CORRIGENDUM - I

Tender Number: IREL/MK//ET/7/2026-27 dated 21.08.2026

Work Description: Request for Proposal (RFP) for selection of agency for installation of De-Sliming system at HUS (MK Unit) on Engineering Procurement Construction (EPC) Basis

ELEVATION
TROMMEL SCREEN FRAME
 (MESH DETAILS NOT SHOWN FOR CLARITY)

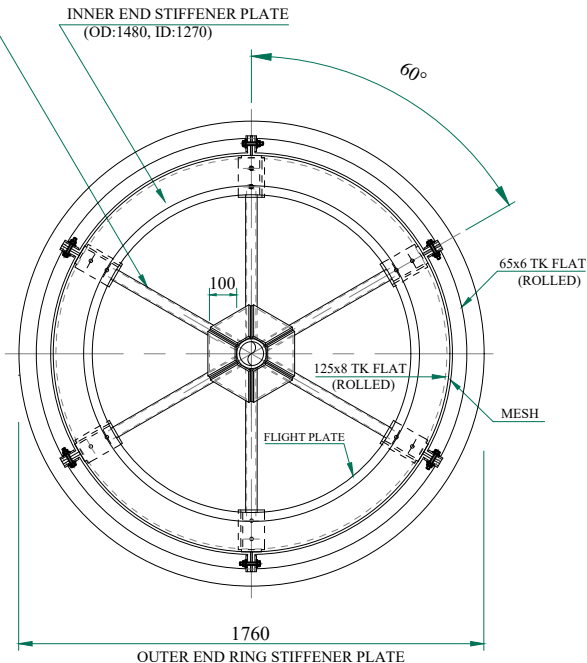
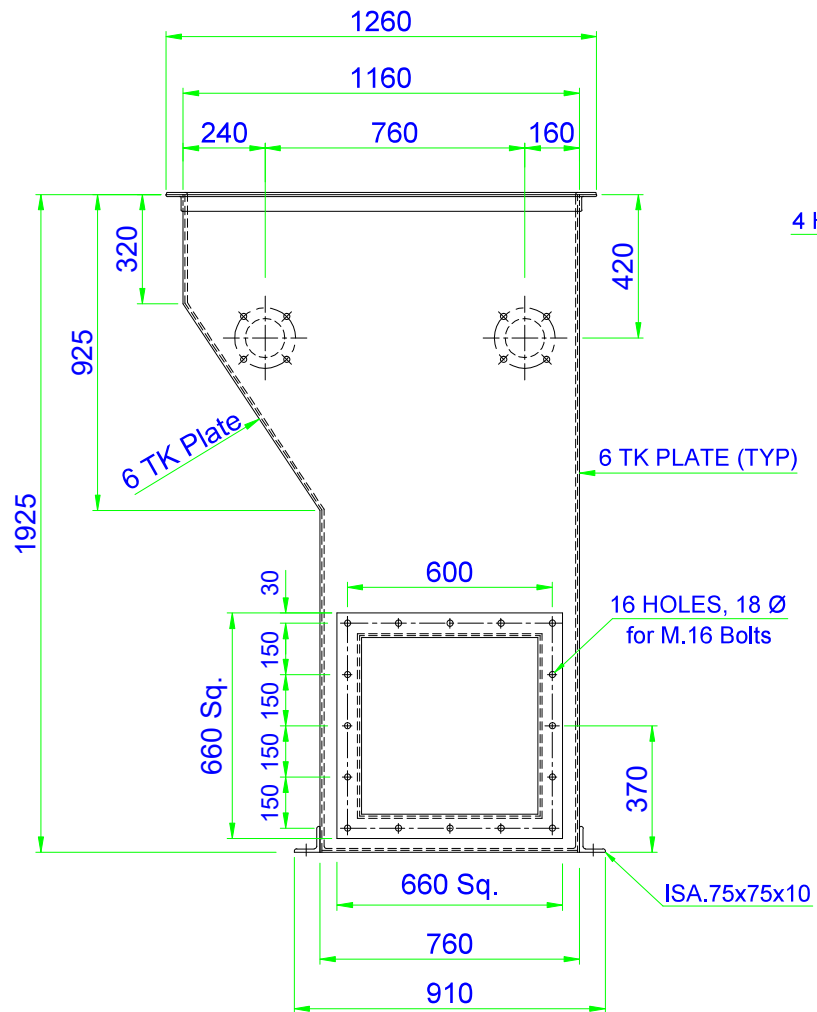
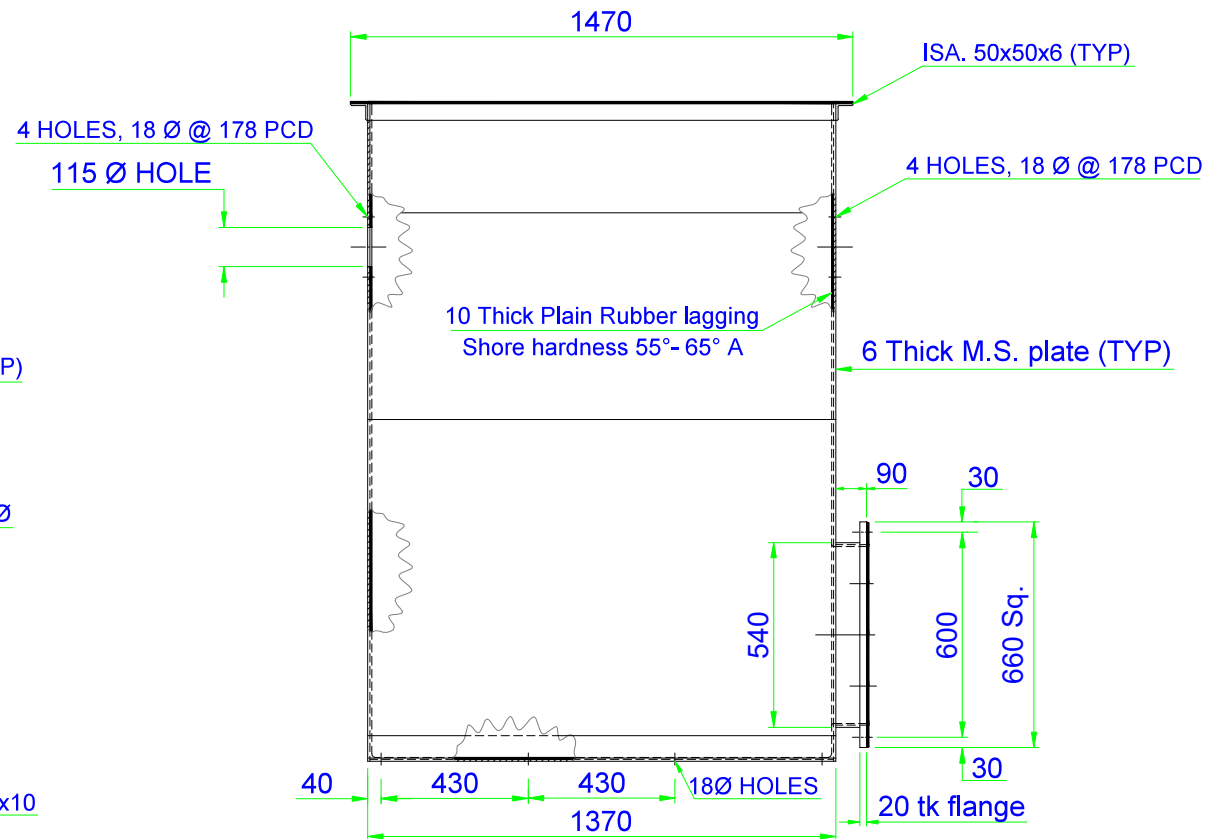
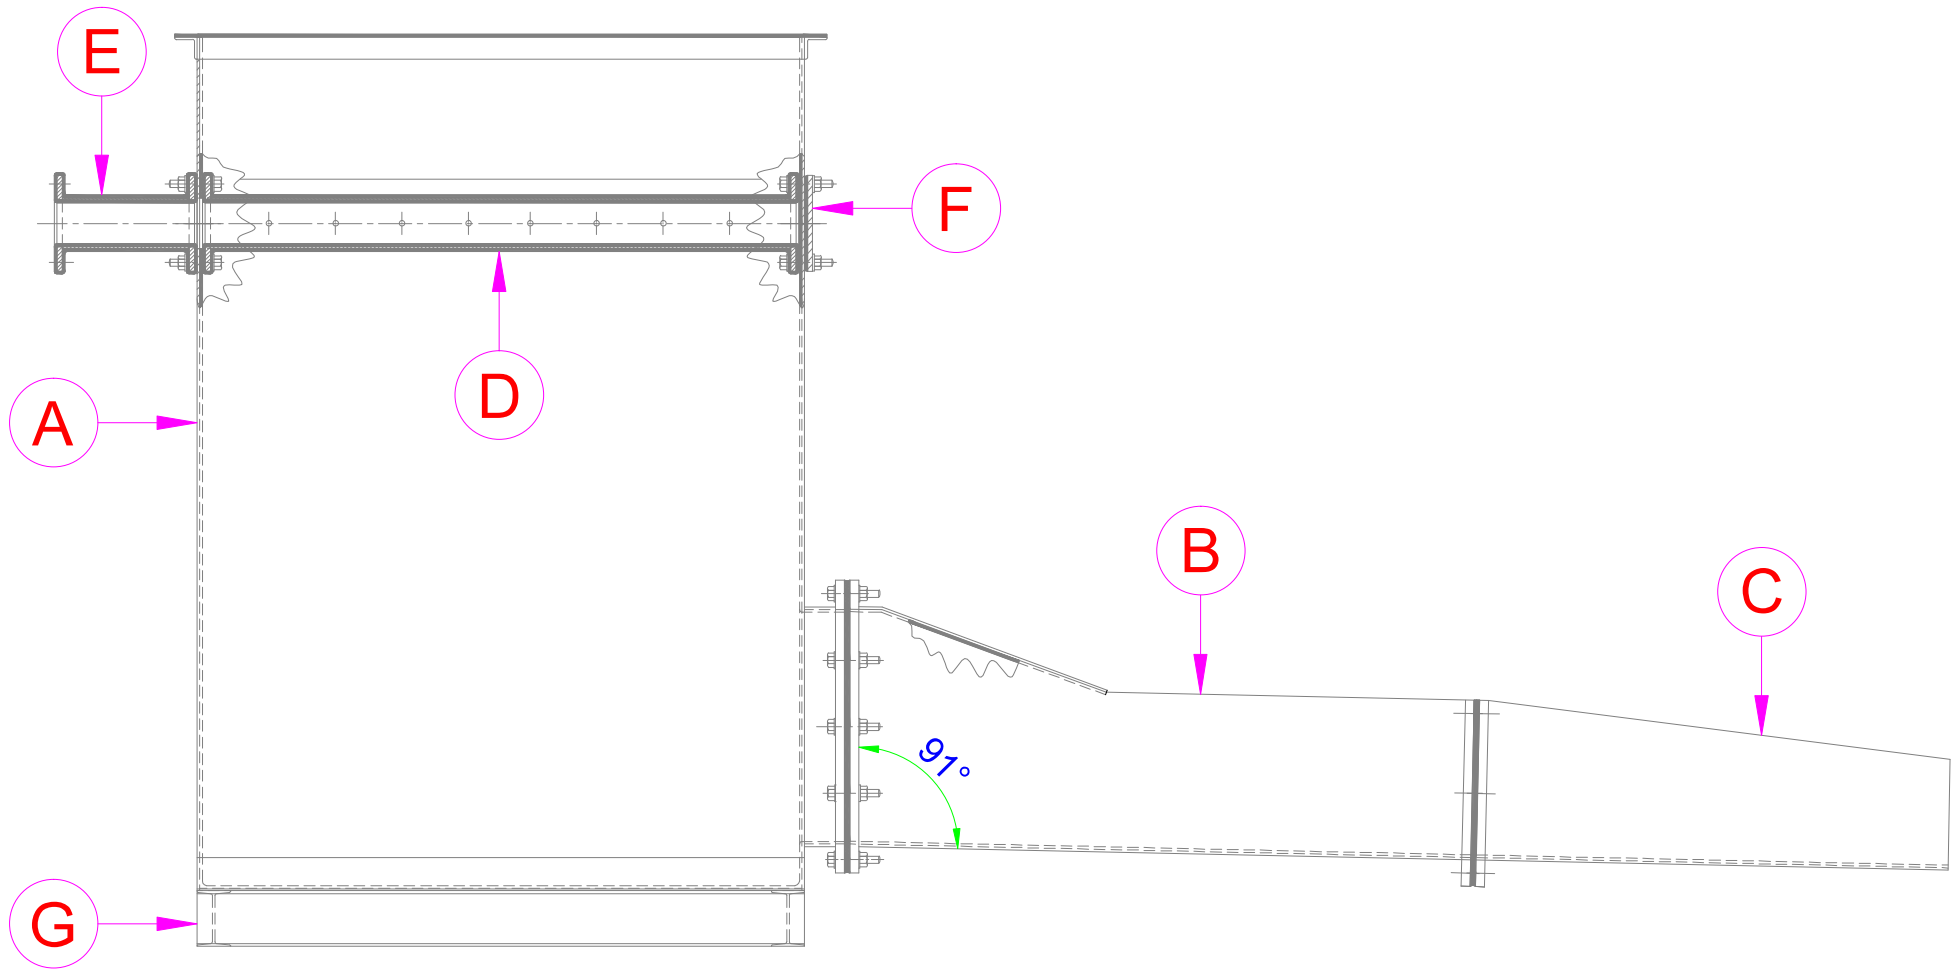
14.			Please provide existing drawings of the trommel screen, mixing chamber, RCC Tank P1 and associated foundations. Required for demolition and installation planning.	Drawings of trommel screen, mixing chamber are attached (Annexure-V). Foundation drawing of RCC tank P1 (around 35 years old) is not available. However, drawing of the superstructure is attached (Annexure-VI).
